**City Of Tacoma
Tacoma Permit Advisory Group**

MEMORANDUM

SUBJECT: Home in Tacoma Proposed Regulations

DATE: March 8, 2024

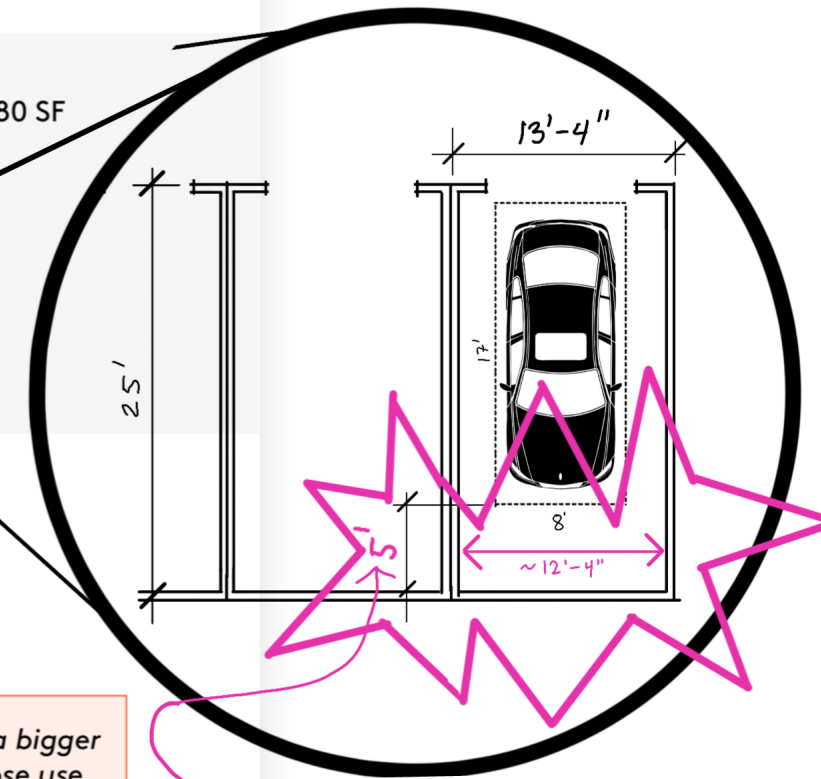
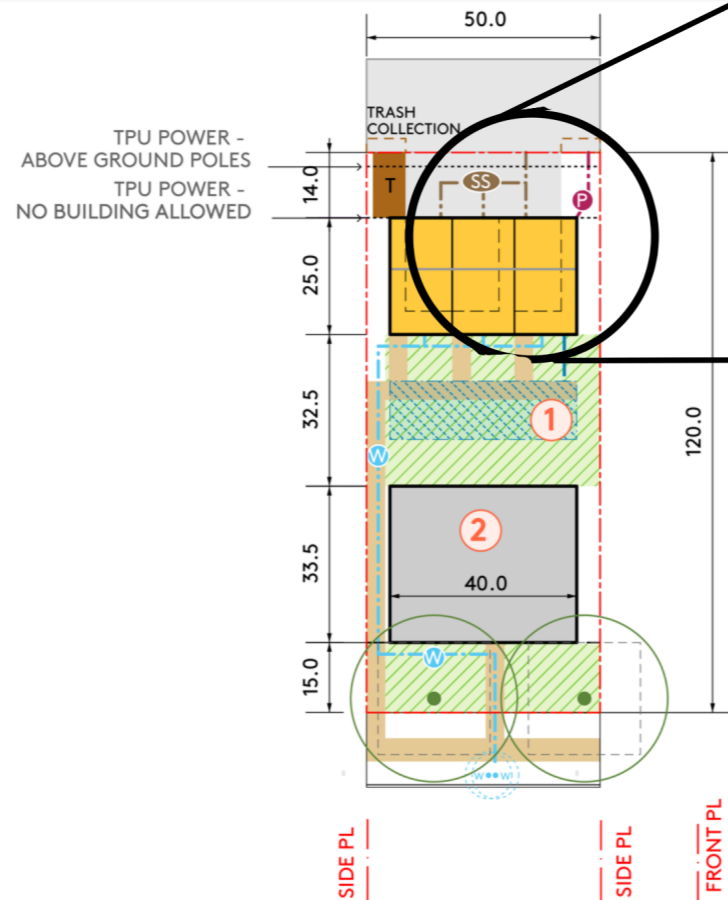
1 Stormwater facility here allows a bigger yard, but doesn't fit trees. Propose use of suspended pavement system to allow tree planting.

13' wide garage townhomes: 1B and 1C show 13'x30' units with a parking stall and "in-unit bike parking." Is it feasible to package a parking stall, bike parking, and a staircase (out of the garage up to 1st floor) all within a 13'x30' area?

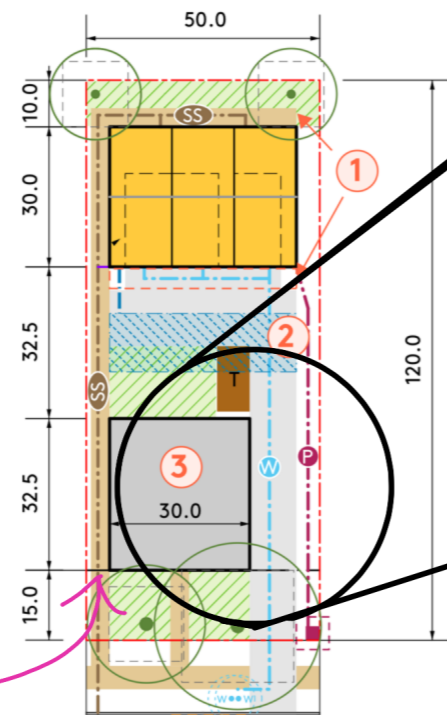
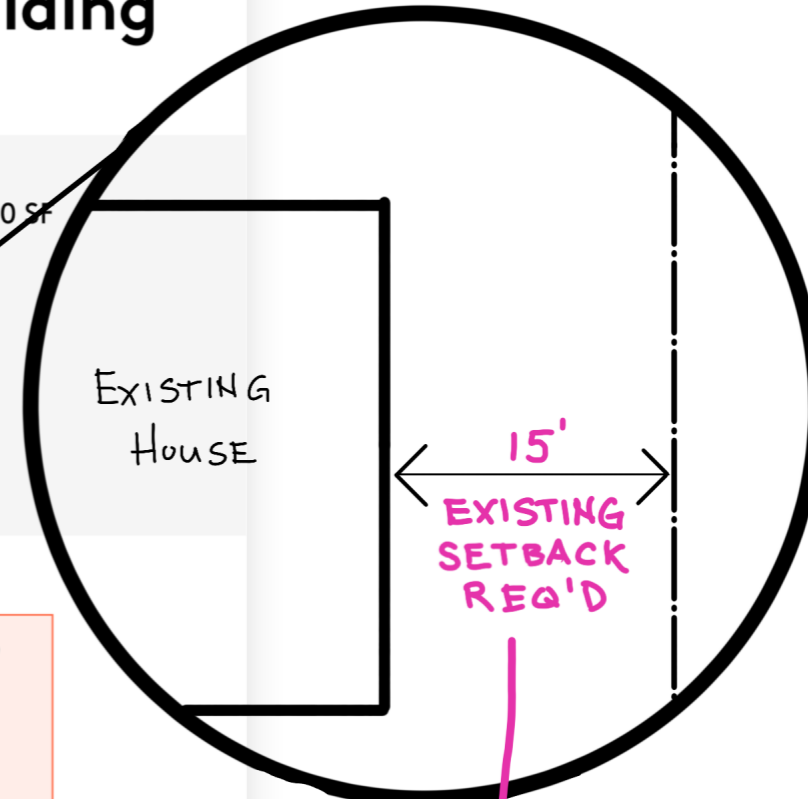
² Stormwater facility here allows a bigger yard, but doesn't fit trees. Propose use of suspended pavement system to allow tree planting.

Forgotten sewer: 1A, 1B, and 1C don't show sewer from the existing home. How would this affect the drawings? In 1A, I believe it would wipe out a tree.

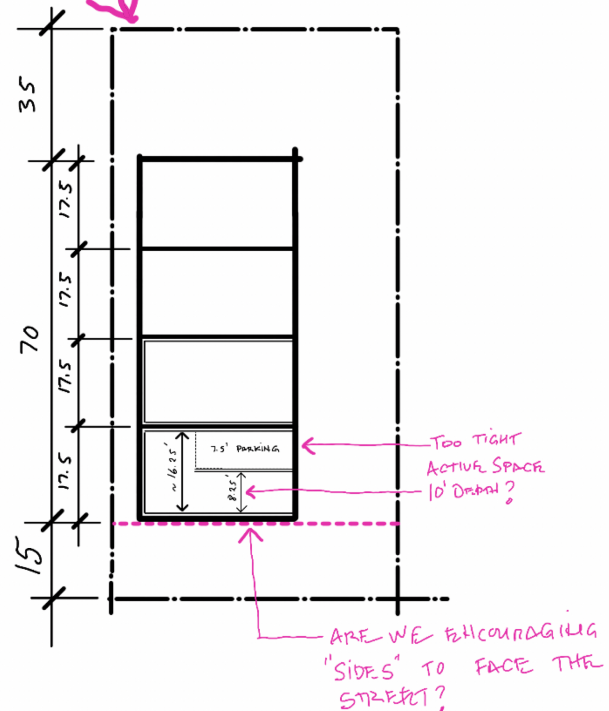
1 This configuration assumes that pedestrian paths are allowed to cross driveways in order to avoid dedicating other side yard to entries which would require more setback and make a skinnier building.
